**RE: Trails at Crowfoot Filing No. 16 – Final Plat
Review Comments 01**

CVL, a Westwood team has considered comments from Town of Parker Planning Department, Town of Parker Development Review Division, Parker Water and Sanitation, Douglas County Department of Community Development, Douglas County Assessor's Office, IREA, Cherry Creek Basin Water Quality Authority & Parker Building Department for the referenced project. We have restated the comments below and addressed them per the italicized responses.

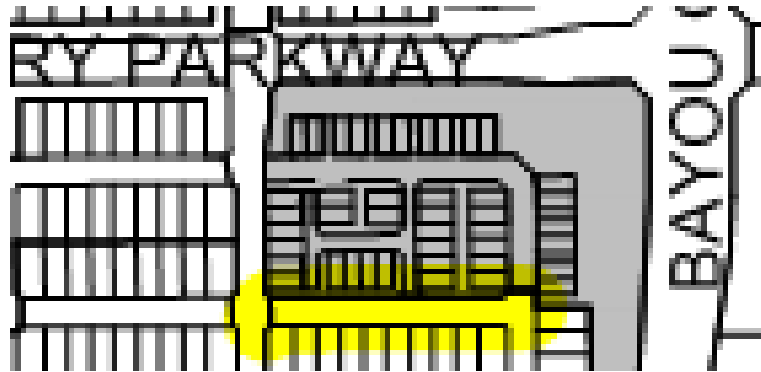
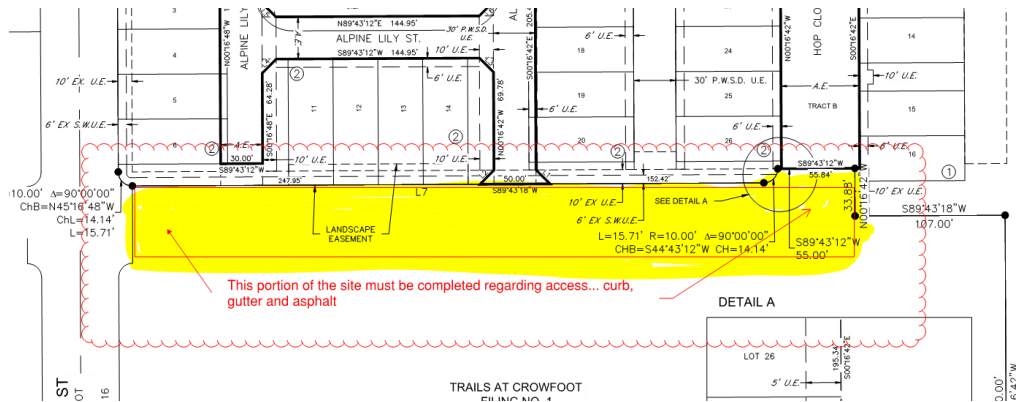
- Comment: The applicant is required to access such that two approved provide two points of access is required for the proposed community. When resubmitting, the submittal documents will be required to include the southern access as a part of the submittal documents. This road shall be shown on all applicable pages and all applicable documents. See below for the area specific to this comment and address fully when resubmitting:

Response: Shasta Daisy St. and Birds Foot Ave have been built and as-builts have been approved by the Town. Access is provided from these streets.

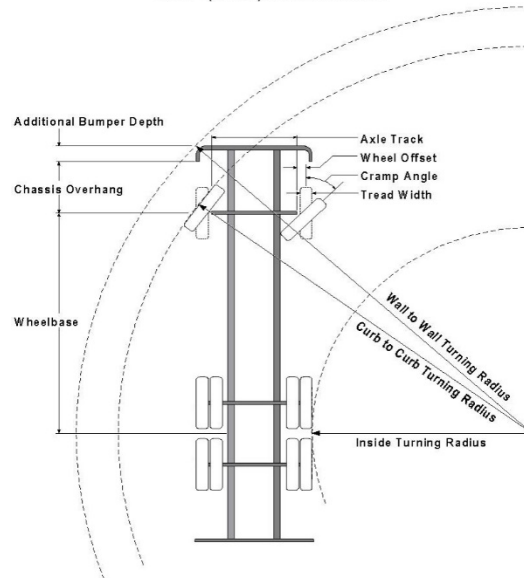
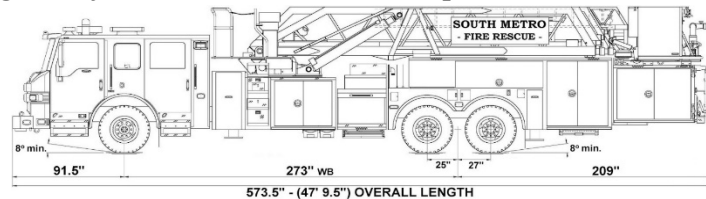
Comment: The minimum unobstructed width of the fire apparatus access road shall be 20 feet. In order to maintain the minimum width and prevent obstructions such as parking of vehicles fire lane signs shall be installed in an approved manner. A minimum vertical clearance of 13 feet, 6 inches shall be maintained for the entire required width of the access road.

Response: Acknowledged, all accesses are 20' unobstructed and have fire lane signs where needed.
